STAFF RECOMMENDATION 2009 19th Avenue South August 21, 2013

Application: New construction-outbuilding; Setback reduction
District: Belmont-Hillsboro Neighborhood Conservation Zoning Overlay
Council District: 18
Map and Parcel Number: 10412016300
Applicant: S. Mitchell Hodge, Architect
Project Lead: Sean Alexander, sean.alexander@nashville.gov

1 SITE PLAN
A-1 1" = 20'-0"

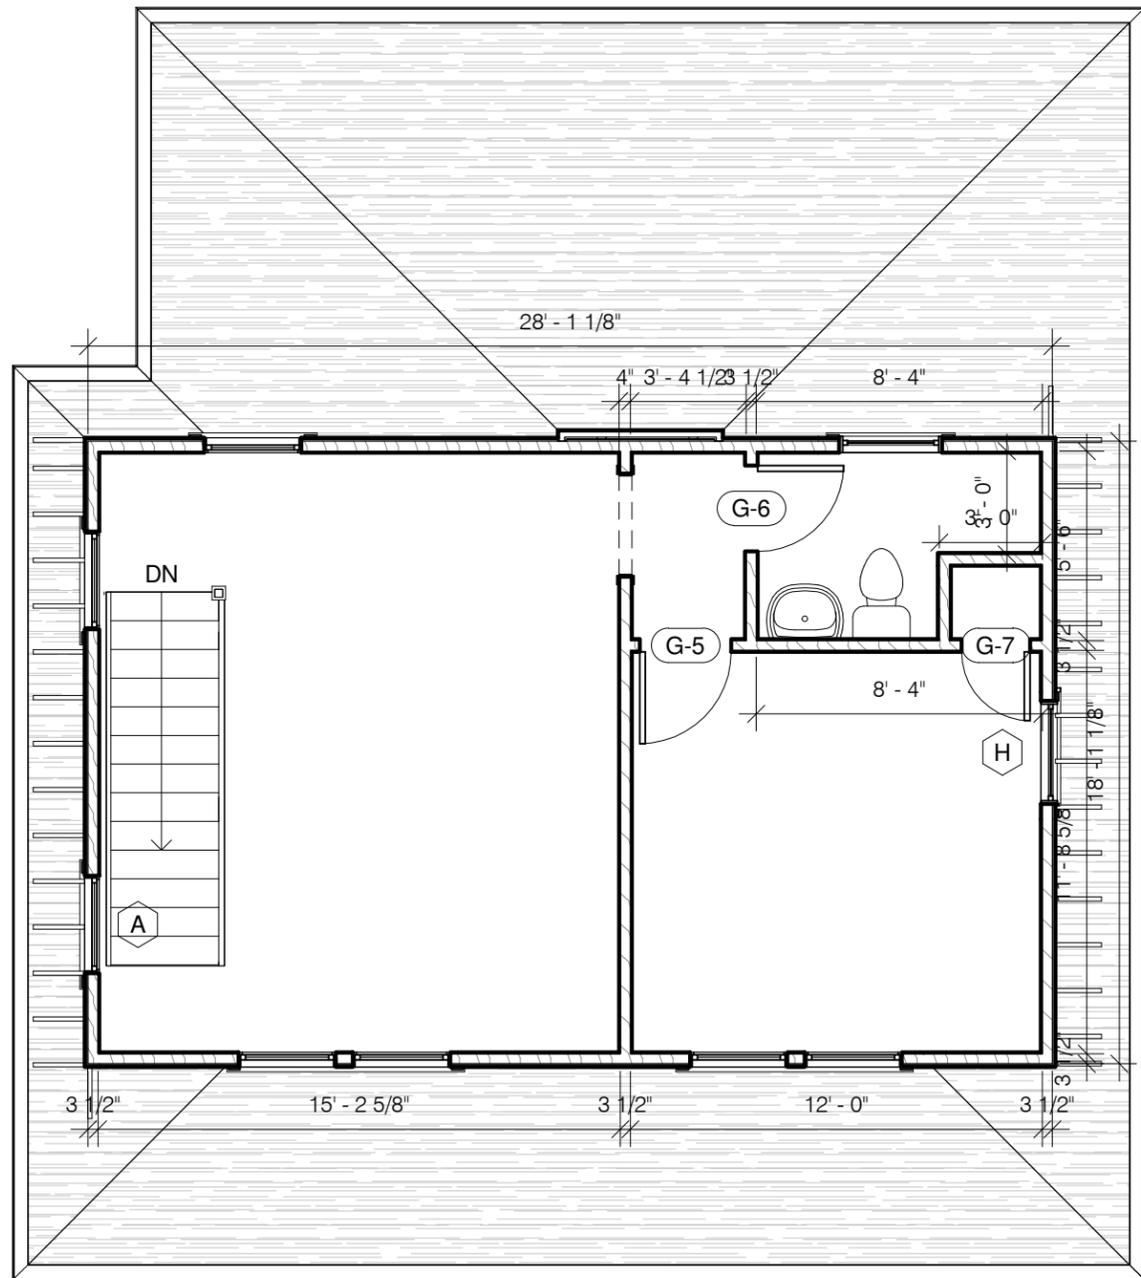
The building would be located ten feet (10') from the rear property line and five feet (5') from the side. The rear setback would be less than the minimum setback required by bulk zoning for an outbuilding of this size, but the location is typical of historic accessory buildings. Placing a large massing, closer than Codes allows would be a concern of Staff; however, the one-story portion of the building is what will be closest to the alley. Staff finds the project to meet guideline II.B.1.c. and II.B.1.i.2.

1 GARAGE
A-2 3/16" = 1'-0"

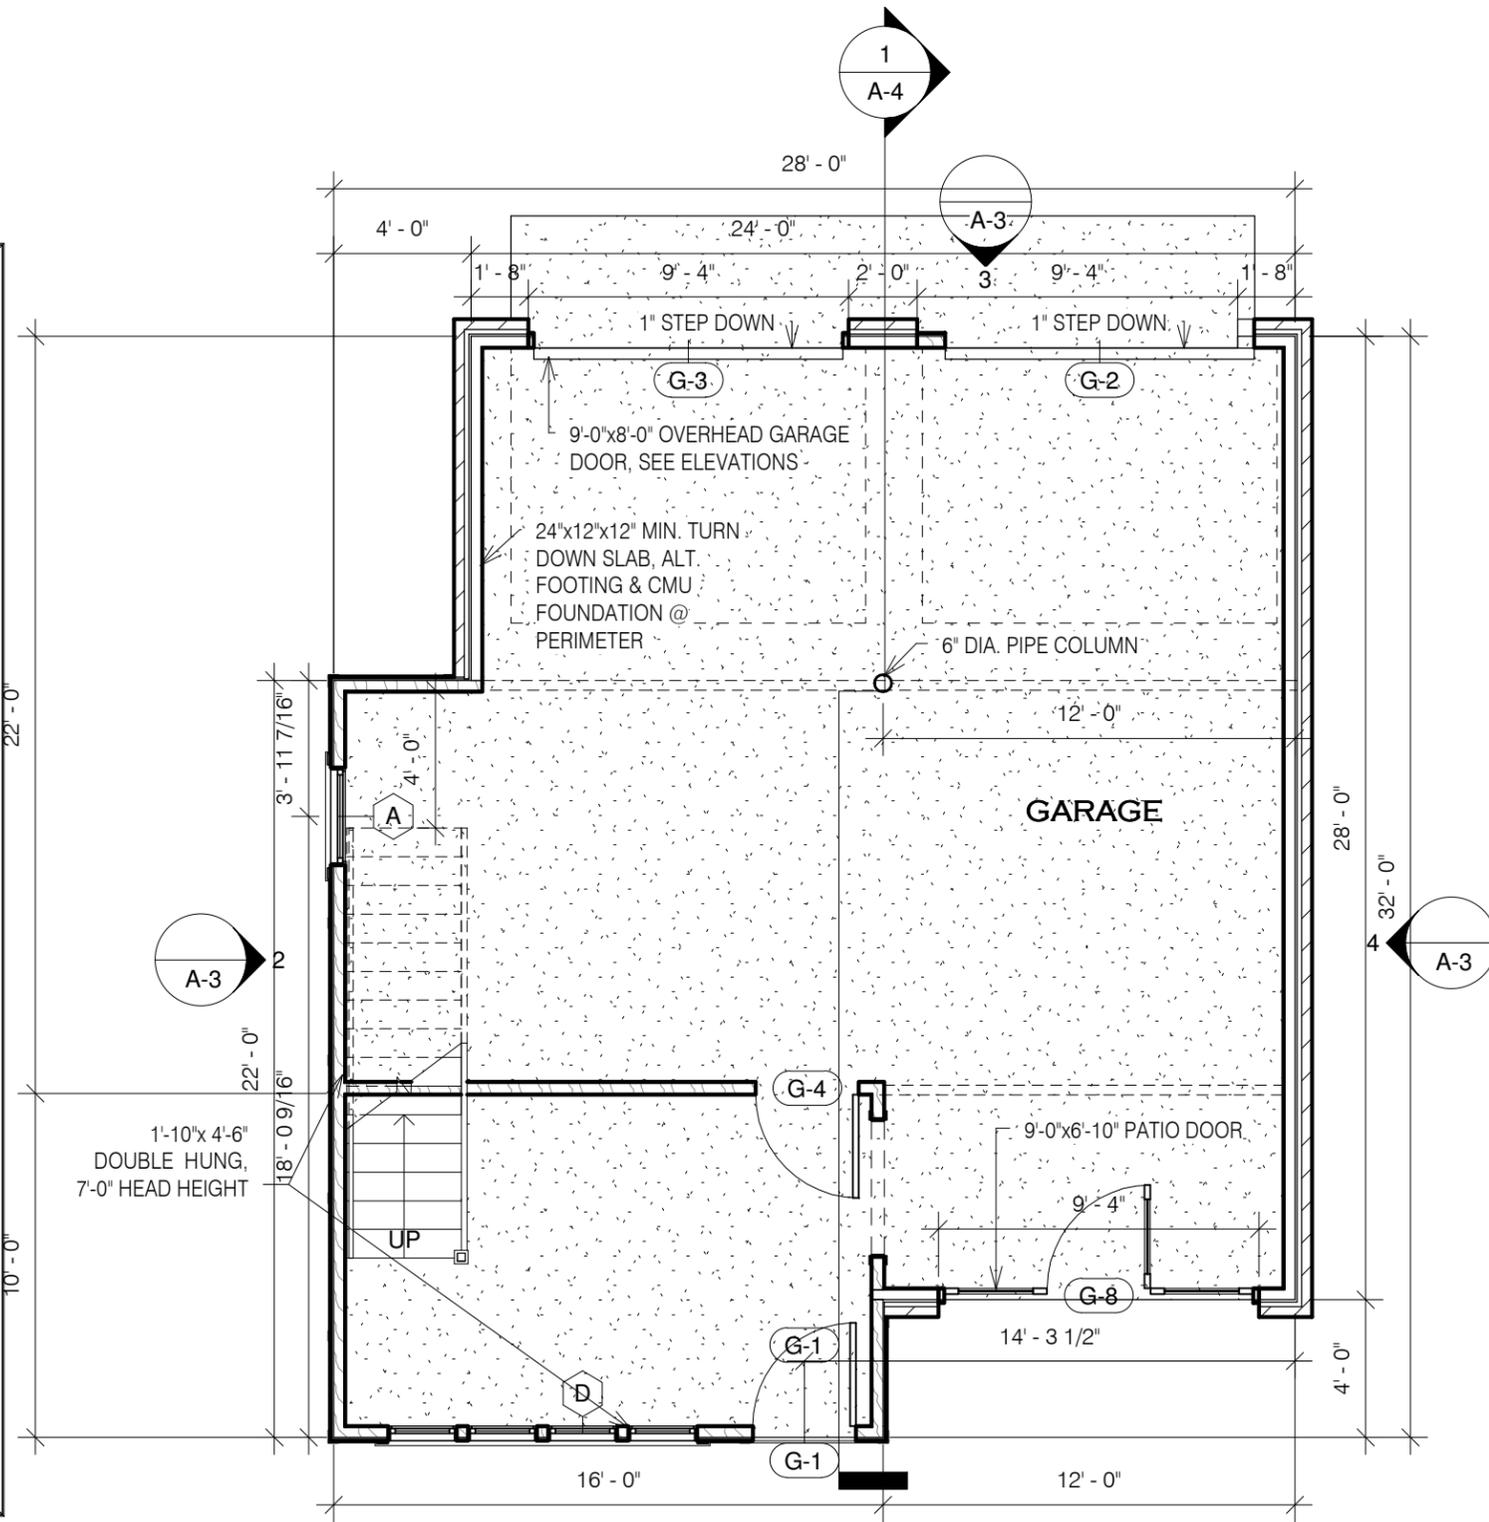
Analysis and Findings: The applicant is proposing to construct a two-story outbuilding with the same footprint as the outbuilding approved in 2011. The new outbuilding will have a two-car garage on the first story and a “bonus room” and half-bath in the upperstory. Because the size of the footprint is larger than would be allowed for a Detached Accessory Dwelling, Codes will not permit the building to have a full-bath or kitchen.

The footprint of the building will be irregularly shaped, as with the structure approved in 2011. Although the area is eight hundred, fifty-two square feet (852’), the overall dimensions are twenty-eight feet, six inches (28’-6”) wide on the East elevation (facing the house) and thirty-two feet, six inches (32’-6”) deep front-to-back. On a rectangular plan this would equate to a nine hundred, twenty-six square (926 sq. ft.) foot area.

The building will have a partial upperstory with a five hundred, twenty-seven square foot (527 sq. ft.) plan. The roof of the building will be hipped with a side-to-side ridge at twenty-four feet (24’) above grade and eaves at eighteen feet, six inches (18’-6”).

1 GARAGE - EAST
A-3 3/16" = 1'-0"

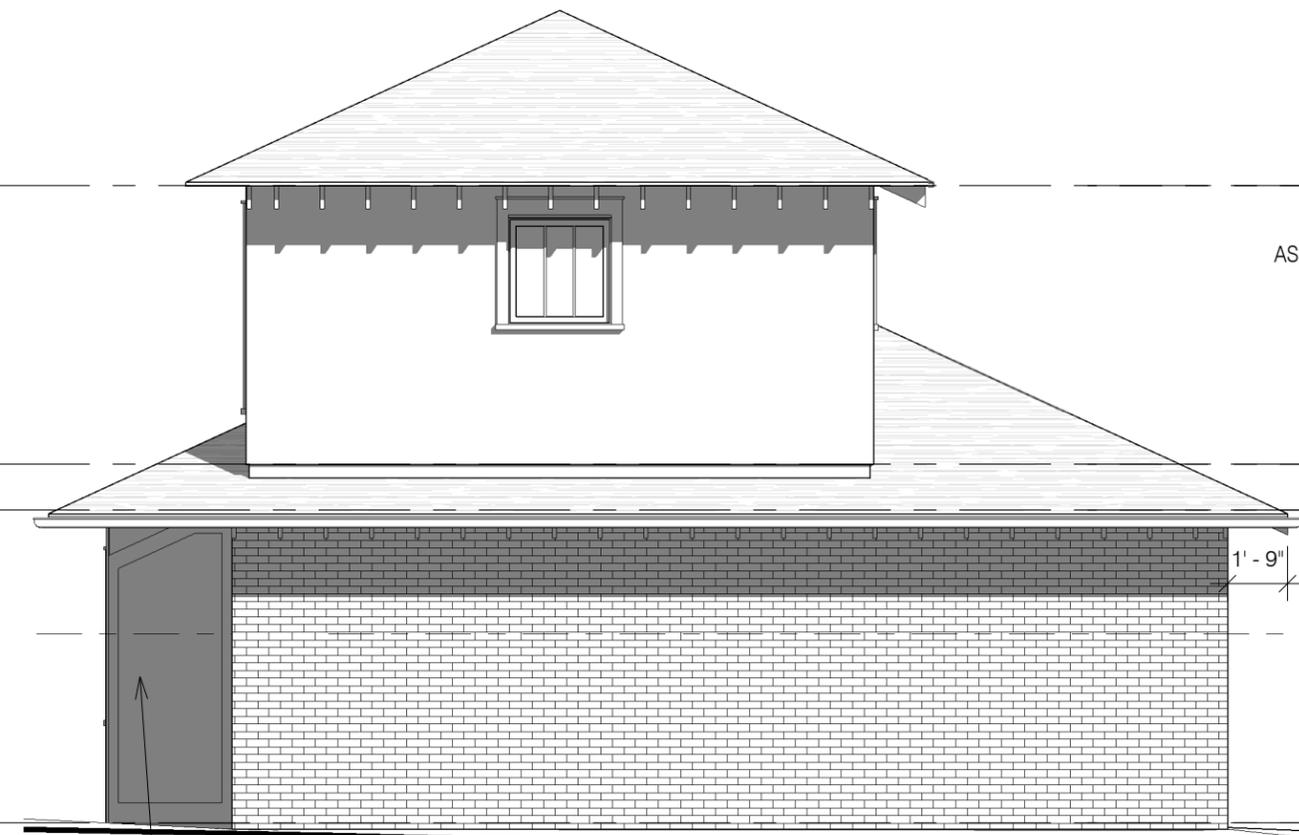
Although the area of the upperstory is less than the first-story by about one third (1/3), the design is such that the massing is greatest on the East elevation. This has the effect of exaggerating the scale of the building, and as viewed from the street the building will not be subordinate to the primary building. Staff finds the height and scale of the current design would not meet guidelines II.B.1.a. and II.B.1.b.

Staff also finds the appearance of the street-facing elevation, twenty-eight feet, six inches (28’-6”) wide with a continuous second-story eave, with two bays on each story, to be very similar to that of an American Foursquare house. Although it is common for outbuildings to reflect the character of the house to which it relates, staff finds the form of the new building to be overly residential in character. Staff finds that the new building would not be sufficiently subordinate to the primary building, which would not meet guideline II.B.1.i.1.

The roof of the upperstory will be hipped with a ridge running side-to-side. The pitch of this roof will be 6:12. The form and pitch of the roof of the first-story will be the same, but because of the different floor areas of the two floors it will resemble a pent roof when viewed from the street. These roofs are compatible with those of surrounding historic buildings and meet guideline II.B.1.e.

Recommendation: Staff recommends disapproval of the proposed two-story outbuilding, finding the scale and massing would not meet the design guidelines for the Belmont-Hillsboro Neighborhood Conservation Zoning Overlay. Staff does not recommend approval with conditions as the alterations necessary to meet the design guidelines will likely require significant redesign of the structure.
